**DRAFT ROUND 10 DAM ASSESSMENT REPORT  
LANSING BOARD OF WATER & LIGHT  
ERICKSON STATION  
ASH POND**

**APRIL 30, 2012**

Re: Round 10 Dam Assessment - Draft Report  
EPA Contract No. EP10W001313  
Lansing Board of Water & Light – Erickson Station  
Ash Pond  
Lansing, Michigan

**Figure 5**  
Ash Pond Structures – Sheet 2

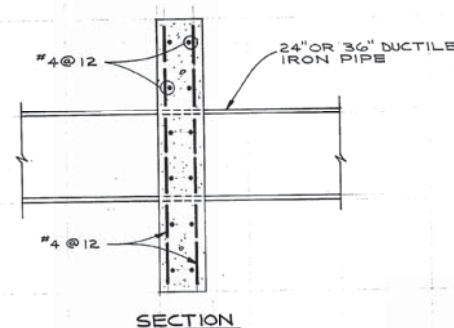
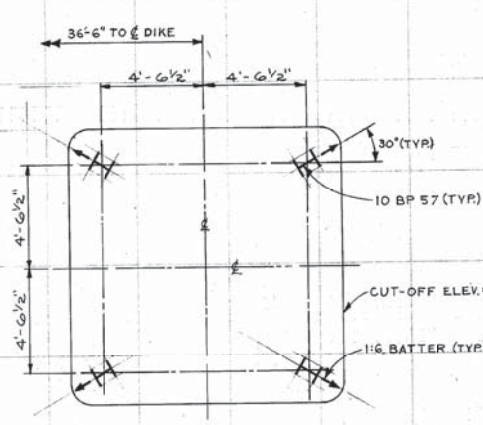
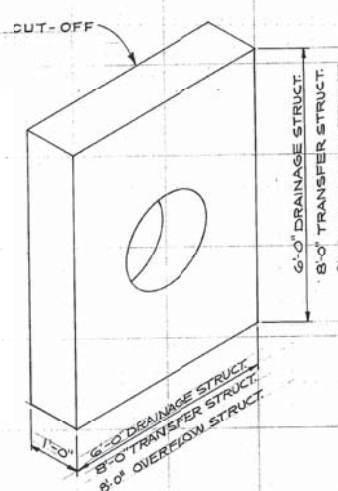
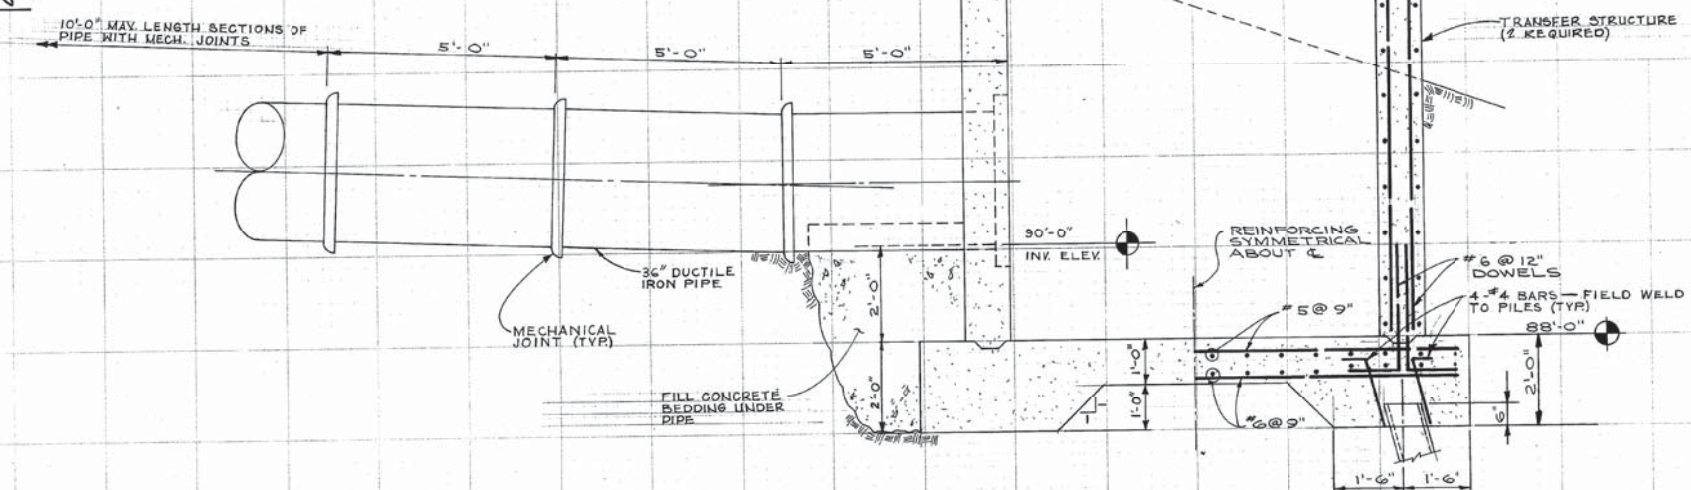
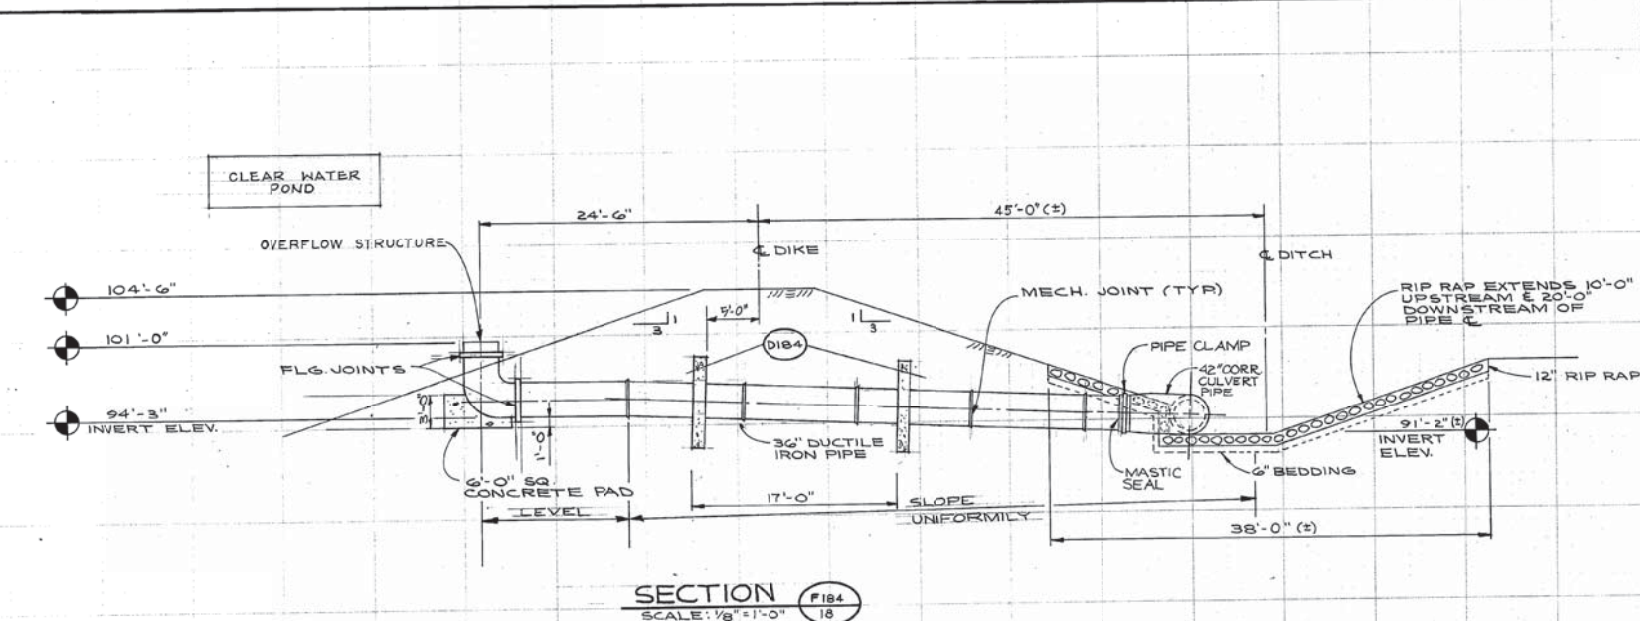
There is no emergency spillway or overflow structure in the Ash Pond. However, there is an overflow structure (refer to **Figure 5**) in Clear Water Pond that is designed to discharge near the toe of the outer dike in the event of emergency overflow. According to LBWL, the overflow structure utilizes one 3-foot diameter ductile iron pipe set at an elevation of 884.65 feet NGVD 29 for emergency discharge from the Clear Water Pond. Two seepage concrete cut-off collars are shown on the transfer pipe. According to LBWL, there has never been a discharge from this outlet.

The overflow structure in Clear Water Pond appeared to be in good condition, but GZA was not able to observe if the inlet was clear of debris (Photo No. 15). The overflow structure outlet appeared to be in good condition with some small brush at the exit (Photo Nos. 37 and 38). GZA did not observe a fence installed at the exit to reduce the chance of animals nesting within the overflow pipe.

2. Clear vegetation and logs from the emergency overflow outlet area and install a fence to prevent animals from nesting in the emergency overflow pipe, if a fence is not already installed;
